Access Compliance Report

Public Rights-of-Way

(Pedestrian Signals)

Intersection ID: N/A	Main Street:	Cross Street: N/A	Location: N/A
ADA ID: 7EA45976CB01	Signal Type: One Push Button-Non APS	Overall Compliance: No	Severity Score: BTN 1: N/A BTN 2: N/A No BTN: N/A
Codes/Mitigation Info/Possible Solution		Field Measurements/Component Compliance

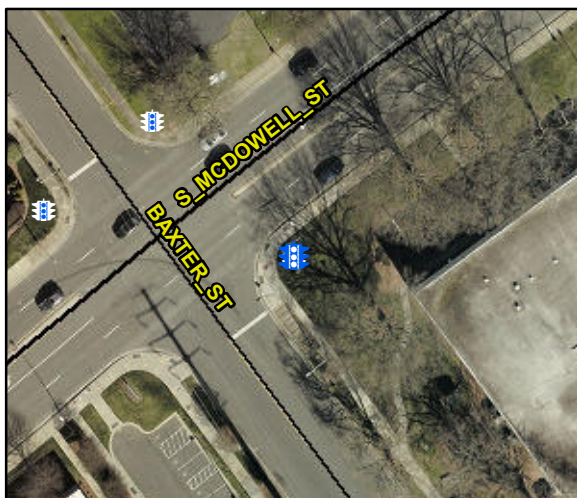
Possible Solutions: Provide PAR As Indicated. Provide Push Button Extension. Remove and Replace Clear Space.

PROW/ADA: R404.3, R404.2, R406.2
